**COUGAR CREEK
DEBRIS FLOOD RETENTION STRUCTURE
Supplemental Information Request Round 1**

SUBMITTED TO:
Alberta Environment and Parks
and Natural Resources Conservation Board

SUBMITTED BY:
Town of Canmore

June 2017

175-2

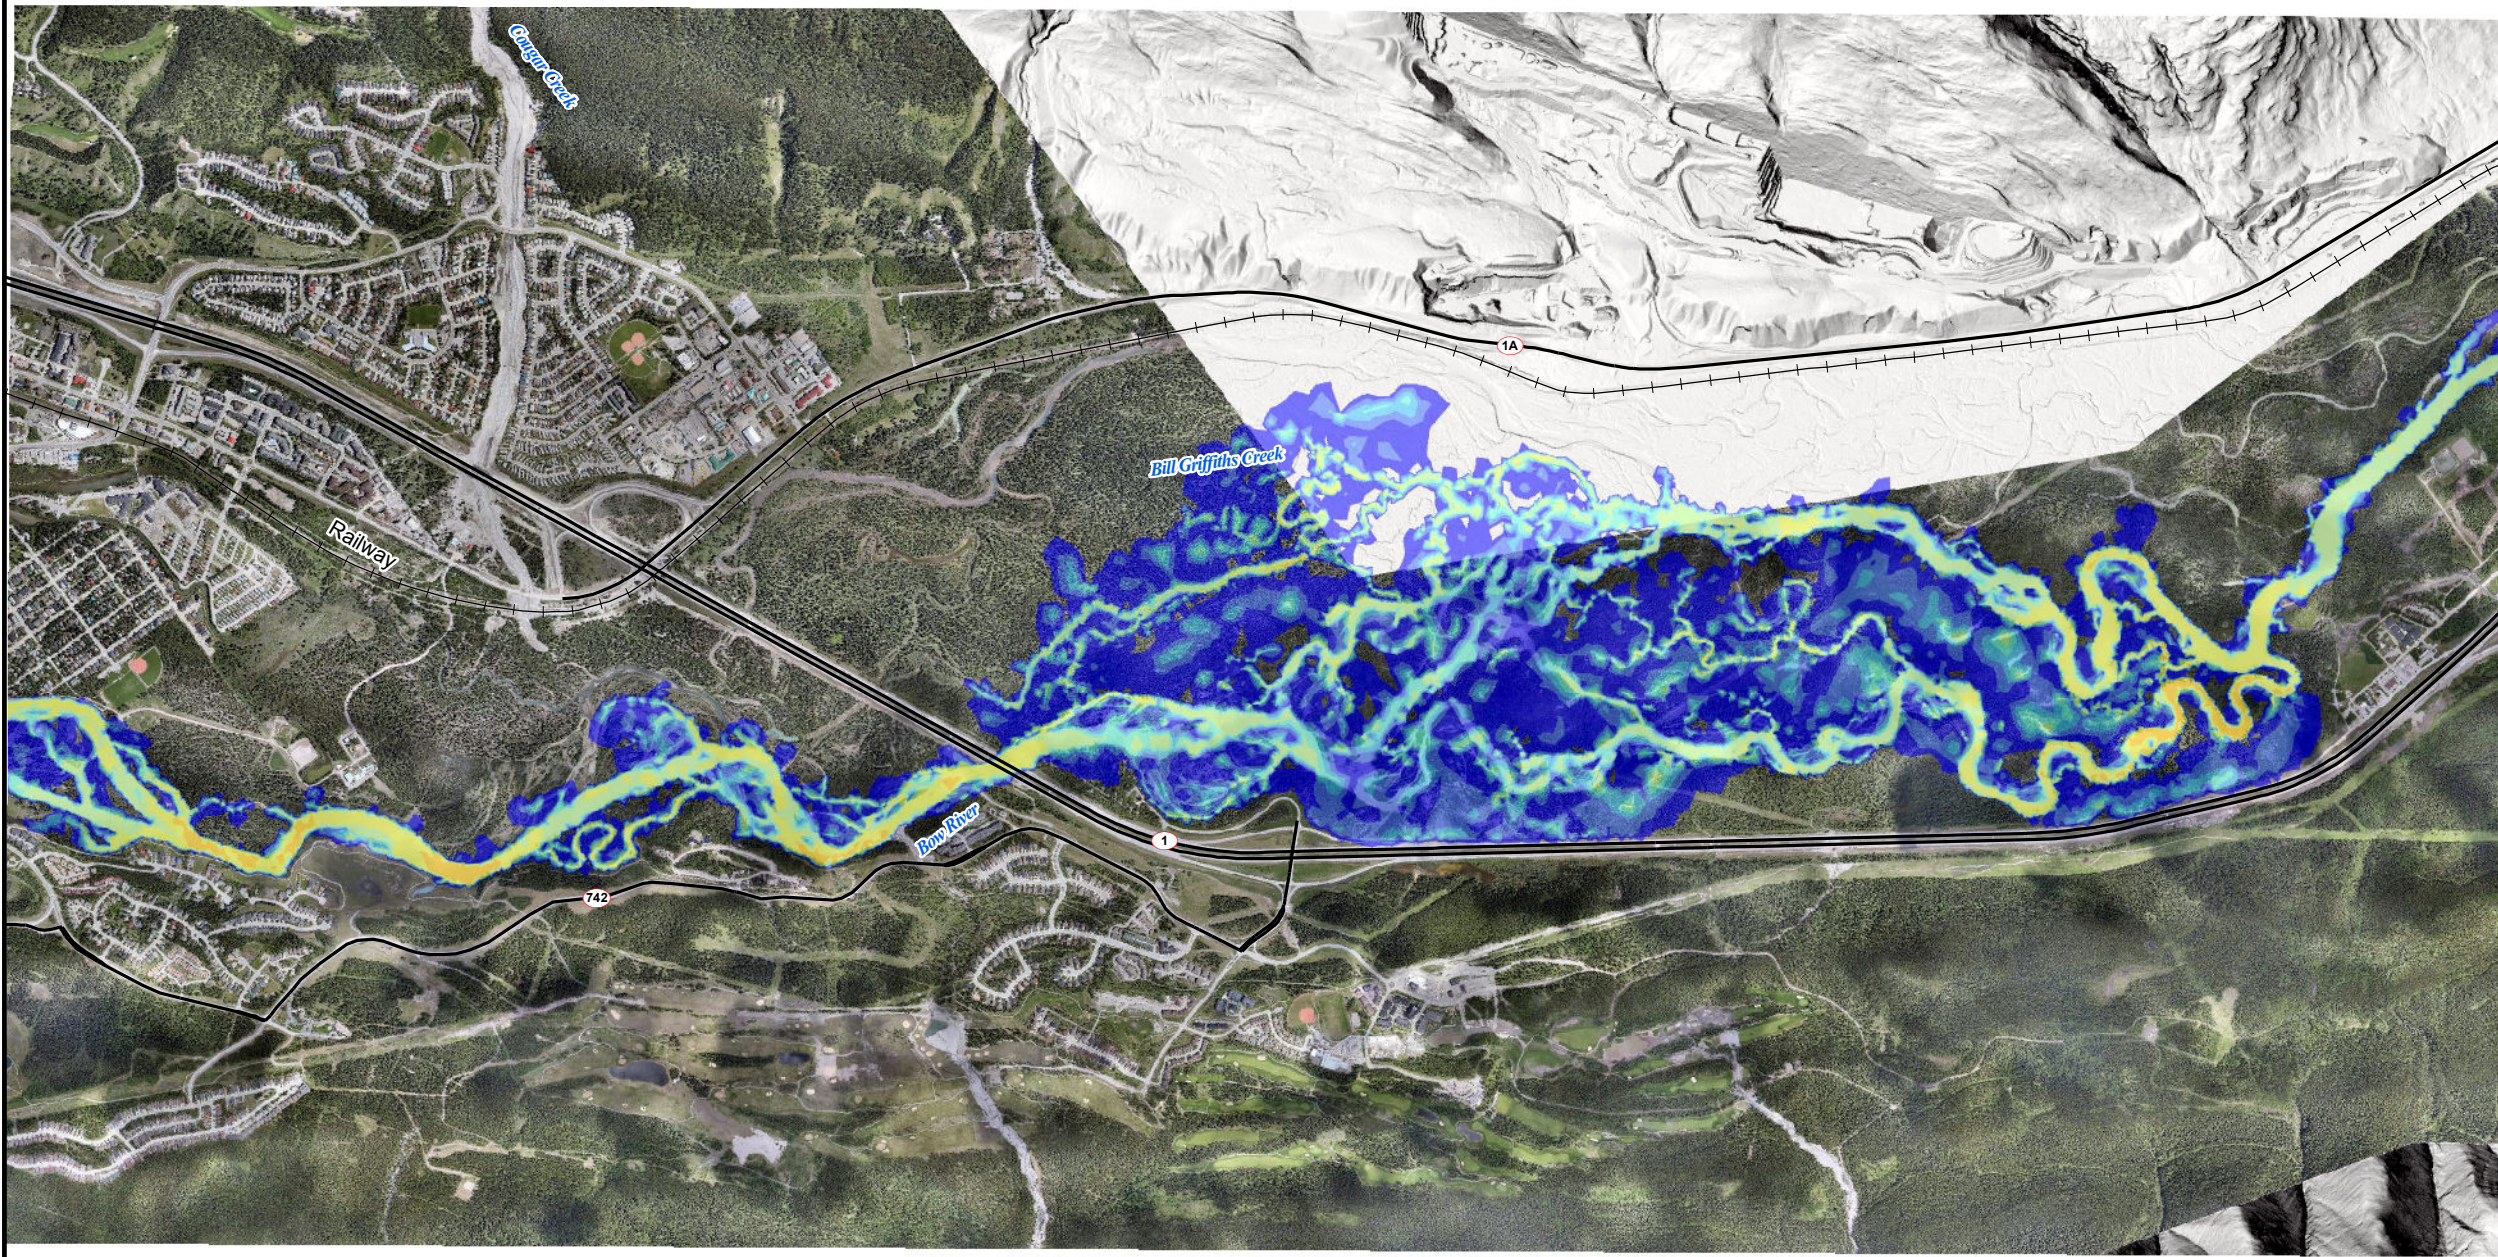
175	<p>Volume 1, Section 10, Figure 10.3-2, Page 10-8 Volume 1, Section 10, Figure 10.3-3, Page 10-9</p> <p>The scale of the map is not sufficient to provide the full extent of the inundation area. Based on the modeled flows and depths, the water would be expected to reach the Bow River.</p> <p>a. Provide figures that show the extent, routes and the locations of confluence with the Bow River.</p>
-----	---

- [Figure 175-2](#) shows the Bow River flooding during a 100-year flood event. The inflow hydrograph data used for the Bow River flood is based on Government of Alberta information that is publicly available.

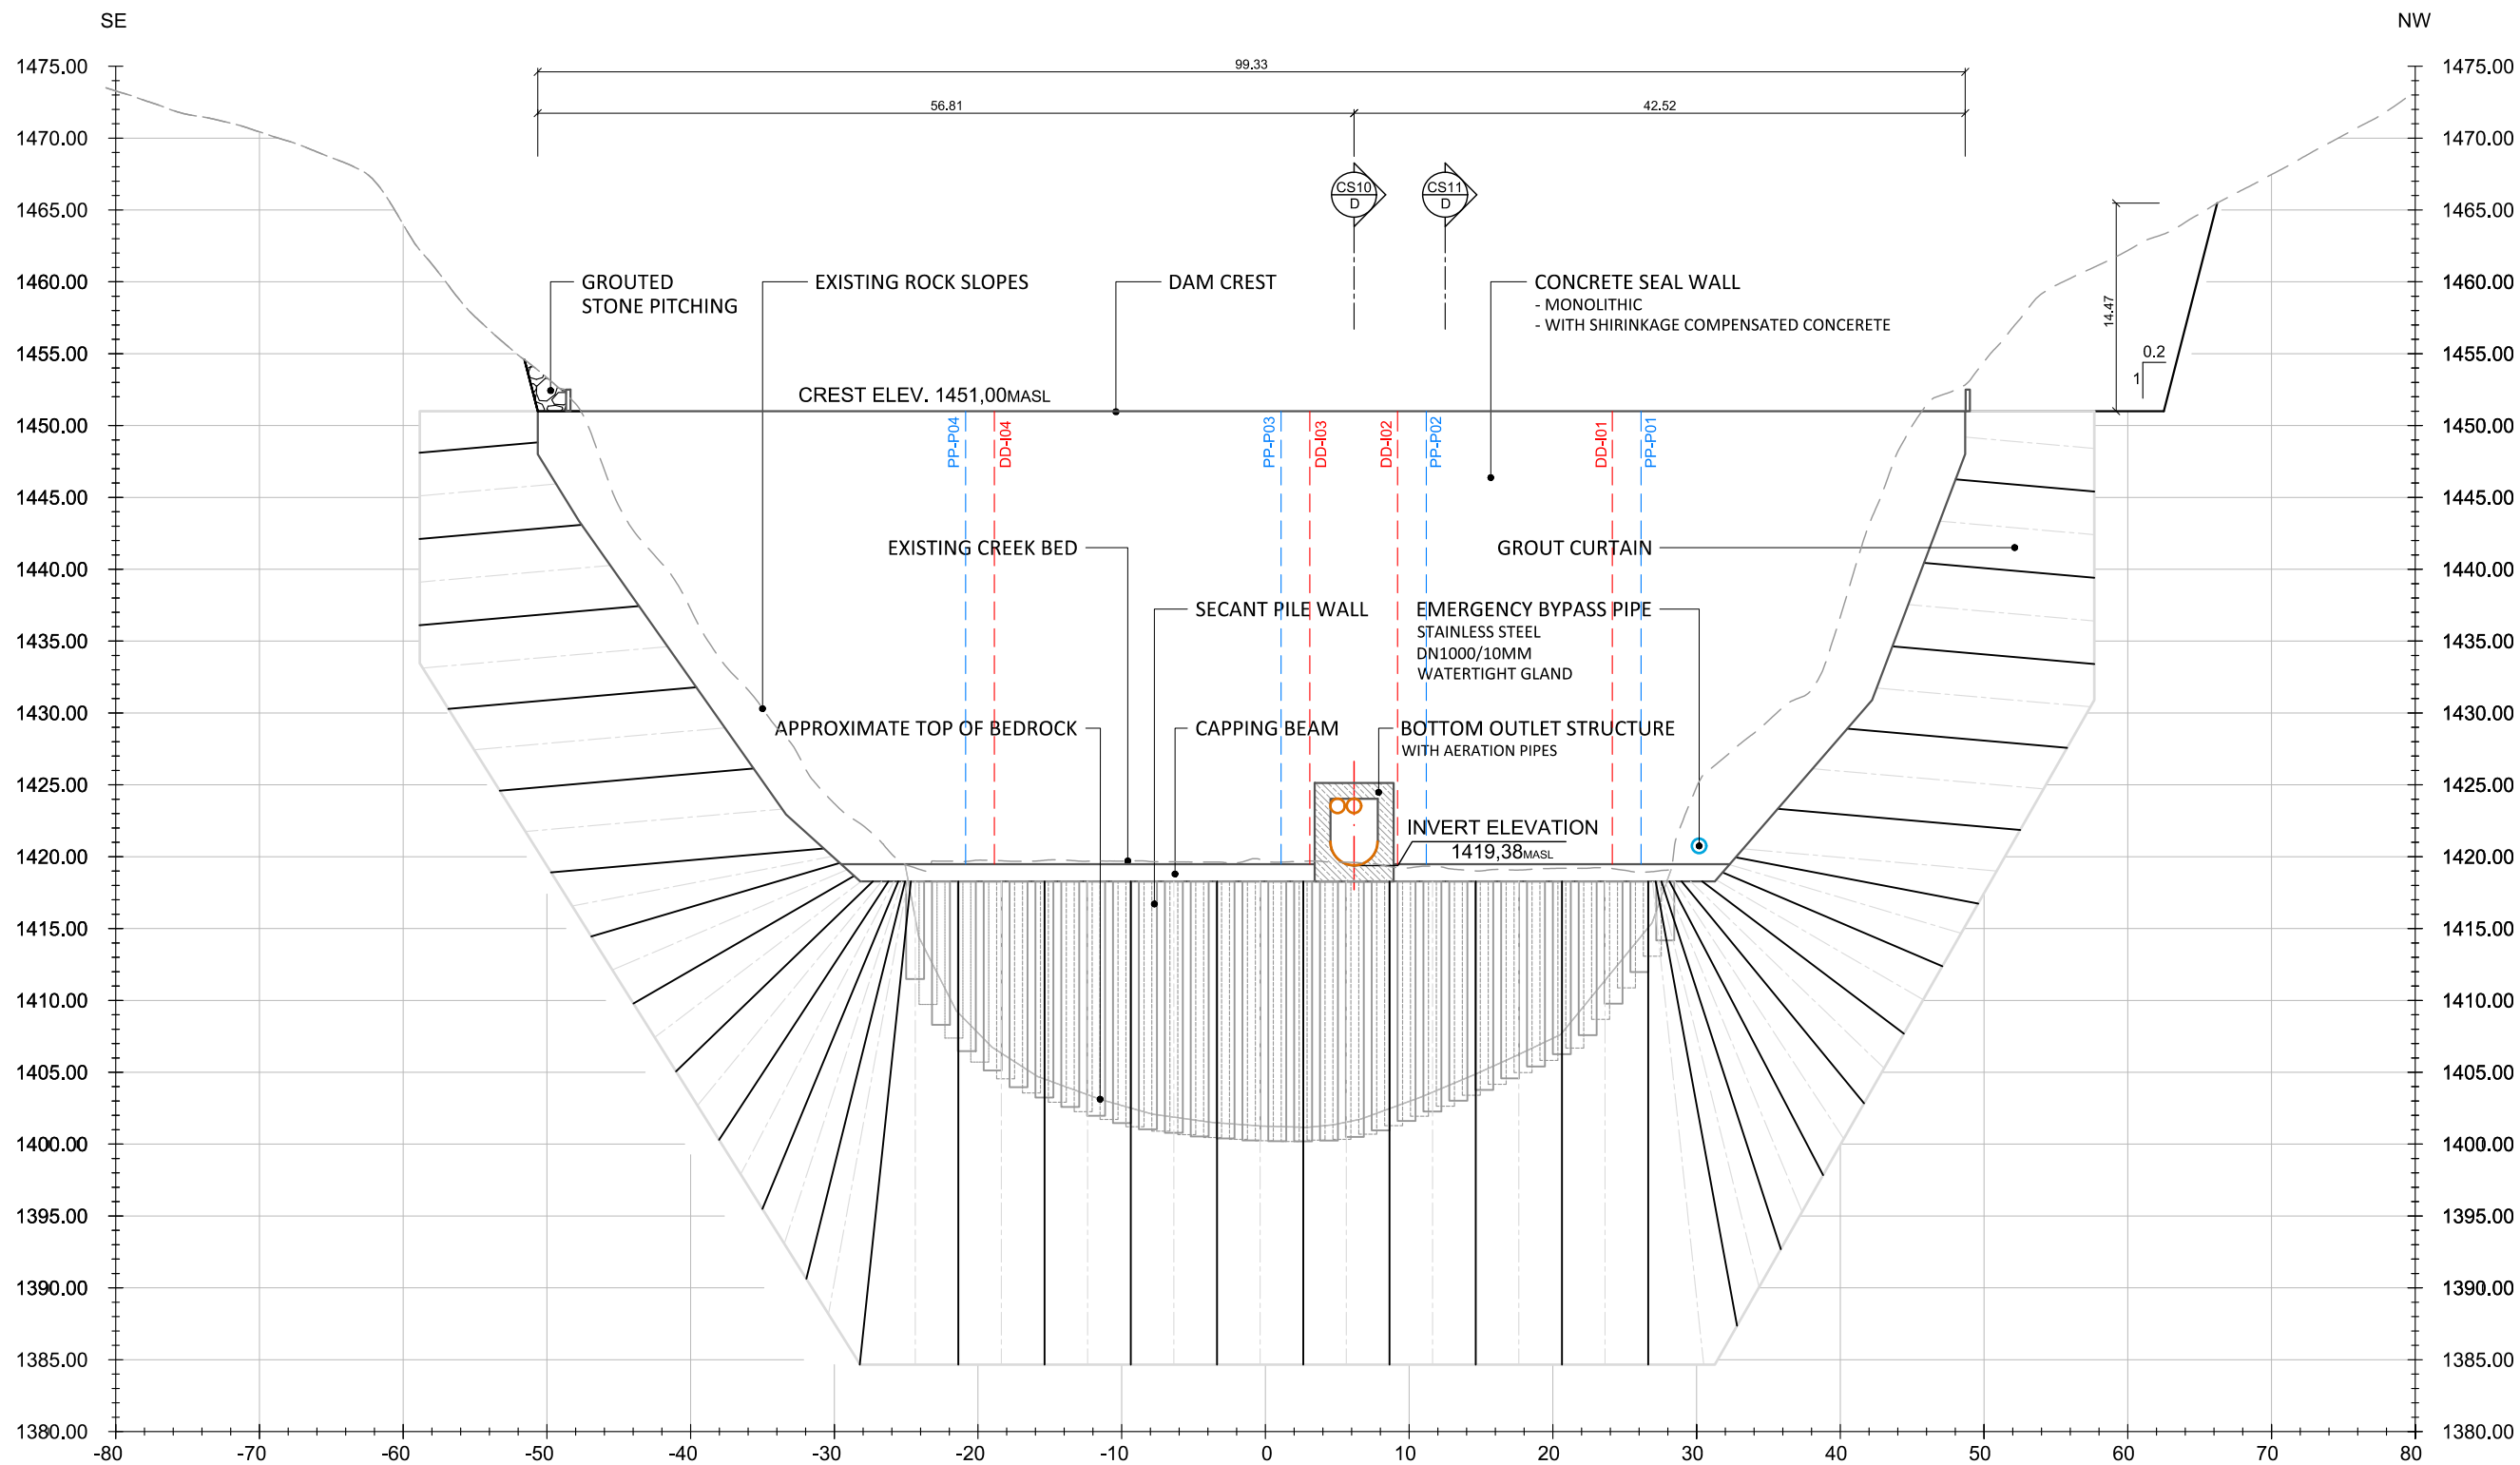
190	Volume 1, Section 4.4, Figure 4.4-4 The figure titled <i>Seepage Control Seal Wall, Cut Off and Grout Curtain</i> is dated June 6, 2013, which seems to be an incorrect date. Provide the correct date and update the required sections.
-----	--

The correct date is June 13, 2016. The updated figure is included here as [Figure 190-1](#).
